Pole Room Mitcham Pole and Lyra Studio Inspection

July 13th 2021

Lyra INSPECTION (Mitcham studio 2)

POLE INSPECTION (Mitcham studio 1)

Studio 2

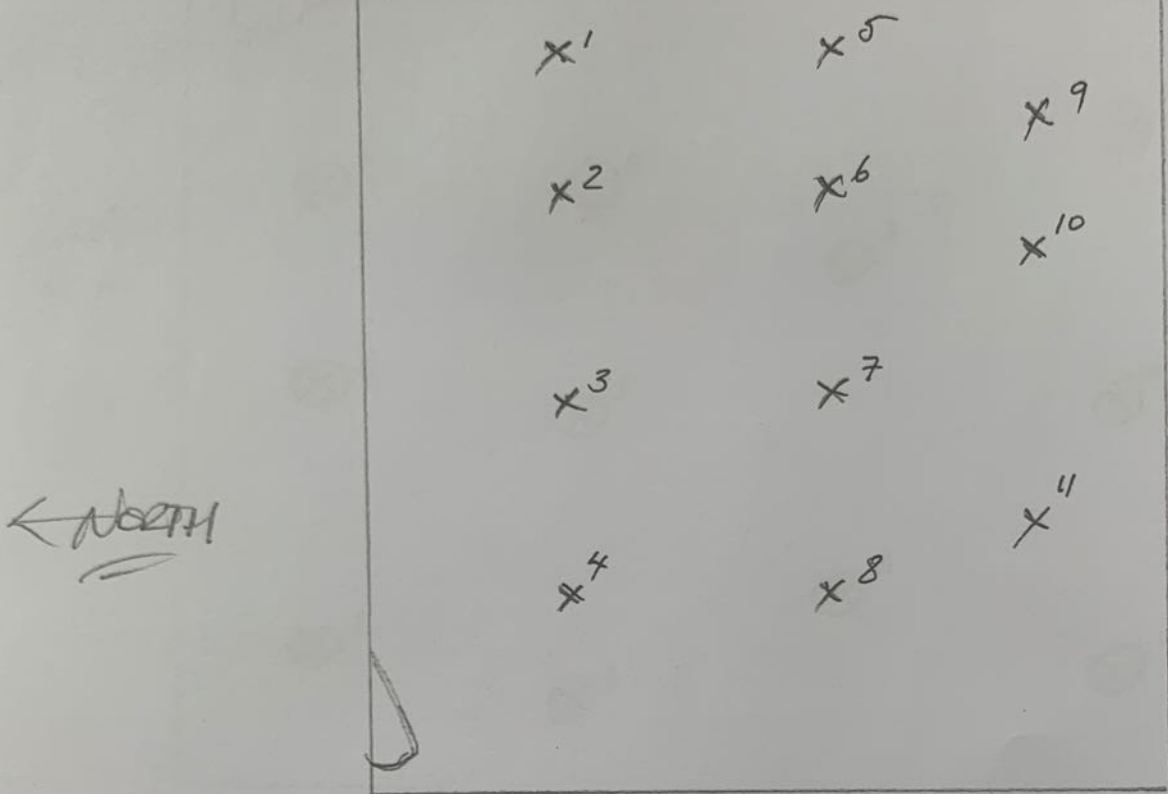
* joining slings to be replaced to enable pass on inspection

Studio 3
pole

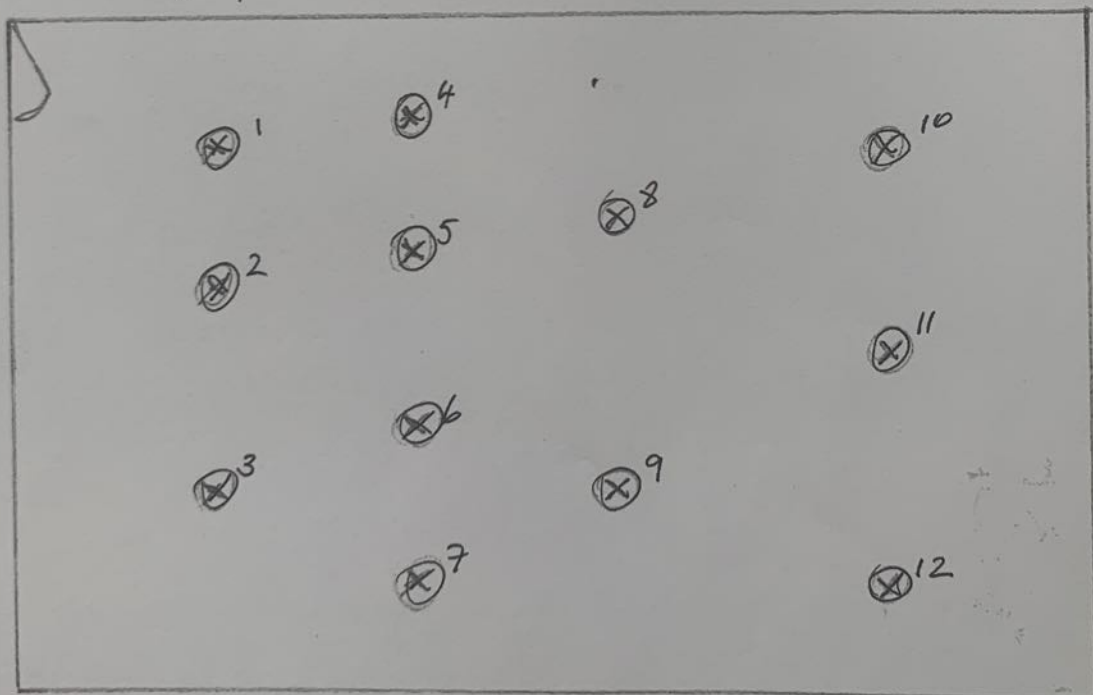
- * Note positions for other poles in this studio, but currently no poles installed in these positions.
- * 8.8 grade bolts should be installed into roof attachment.
